McCALL AREA
PLANNING AND ZONING COMMISSION

Agenda

April 6, 2021 – 4:30 p.m.

PROPOSED RECORD OF SURVEY

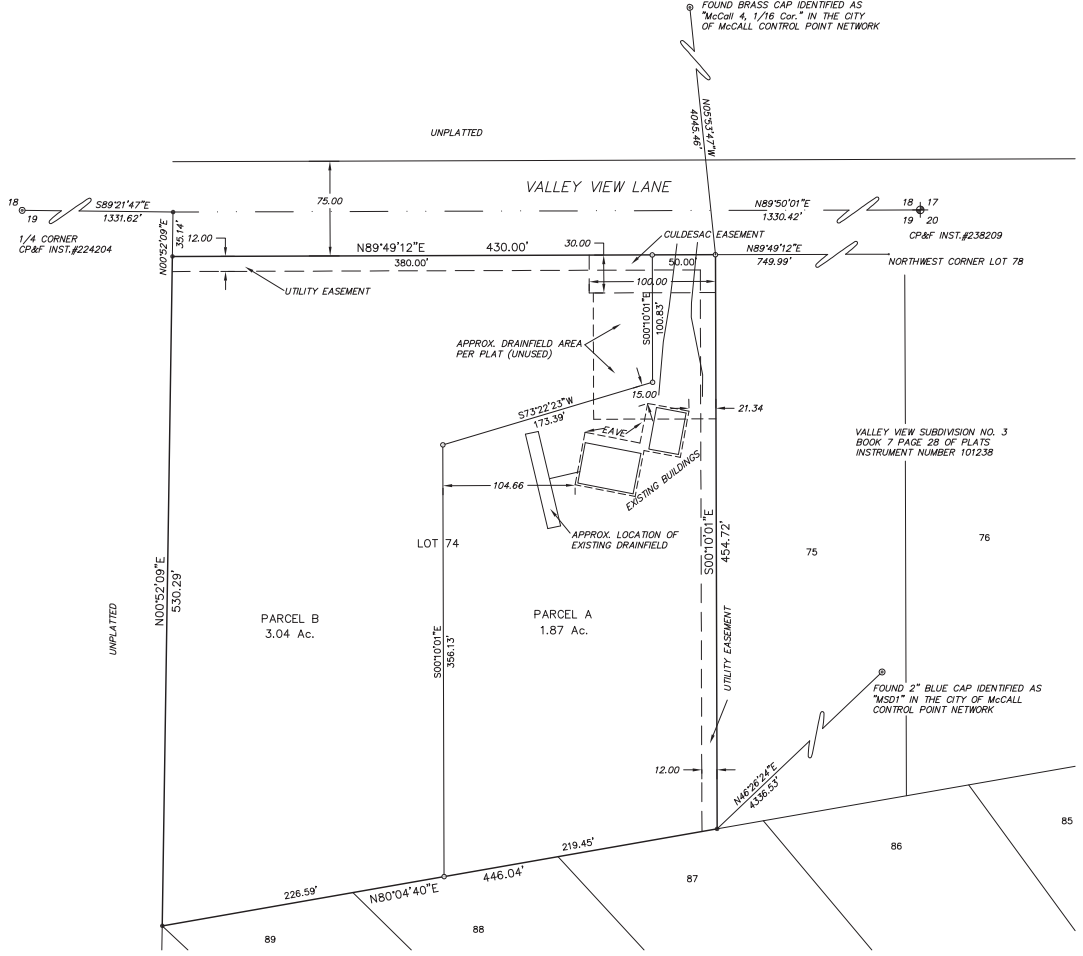
1. There are a few existing items from the [Valley View Subdivision No. 3](#) that are missing from the preliminary Record of Survey:
 - a. Drainfield area just south of the cul-de-sac easement.
 - b. 12’ utility easement inside all lines along roads.
 - c. 12’ utility easement centered on all interior lot lines.
2. Please provide the total width of Valley View Lane in this Record of Survey.
3. Once the final ROS draft is complete, two digital CAD files, prepared in accordance with the City’s digital data submission standards (DDSS) shall be provided. The complete DDSS guidance document can be found here: <https://evogov.s3.amazonaws.com/141/media/115532.pdf>

1. There are a few existing items from the [Valley View Subdivision No. 3](#) that are missing from the preliminary Record of Survey:
 - a. Drainfield area just south of the cul-de-sac easement.
 - b. 12' utility easement inside all lines along roads.
 - c. 12' utility easement centered on all interior lot lines.
2. Please provide the total width of Valley View Lane in this Record of Survey. (Items #1 and #2 have been added in a revised Record of Survey)

PROJECT: 202302A DATE: 11/15/21
DRAWN: AFM CHECKED: LCL
SHEET TITLE: DEMO & LANDSCAPE PLAN
SHEET: C.0.1

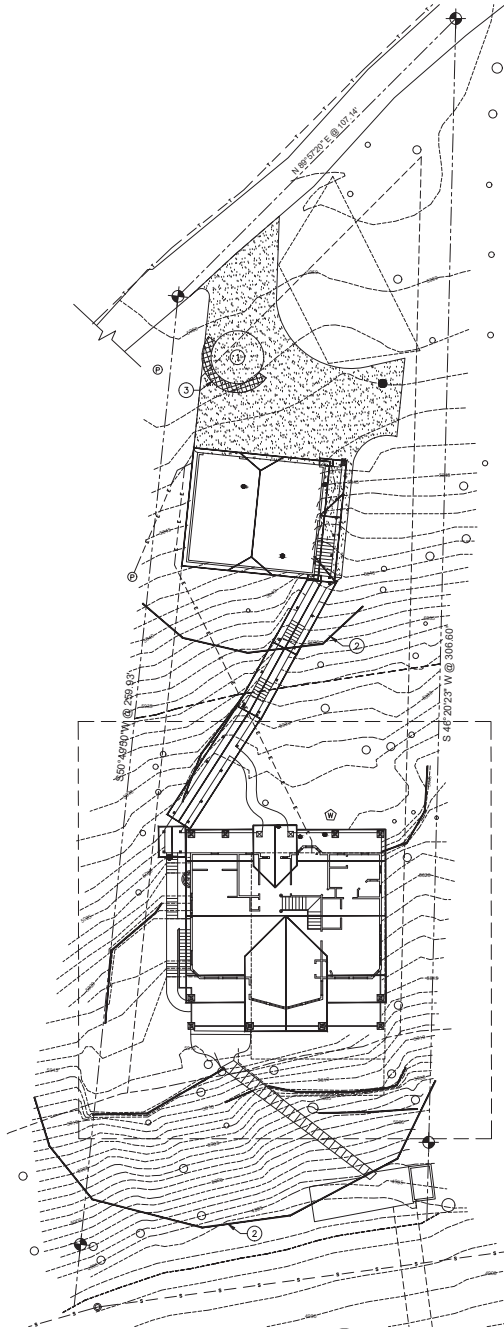
2. There will be work performed within the 150' setback also known as the "Shoreline and River Environs Zone". The existing residence will be demolished and replaced with a new residence. The hatched area on drawing C.0.1 – 1 is showing the extents of required excavation for the new residence. Please refer to note number 5 on drawing C.0.1 – 1. It should be noted that while the new residence will be a two (2) story structure, the building footprint will be reduced from 2,050 square feet for the existing residence to 1,924 square feet for the new residence resulting in 126 square feet being returned/added to the landscape. All new and proposed walkways, driveways, patios, and permanent buildings have been considered for lot coverage calculations. There are no new walls or fences planned within the 50' setback from the "high water mark" of Payette Lake. All other stairs and retaining walls within the 50' setback from the "high water mark" are existing to remain and have been noted with an "(E)" on our plans for clarity.

on sheet C.0.1 – 2 has been diagrammed to help illustrate what areas are being counted in lot coverage calculations.
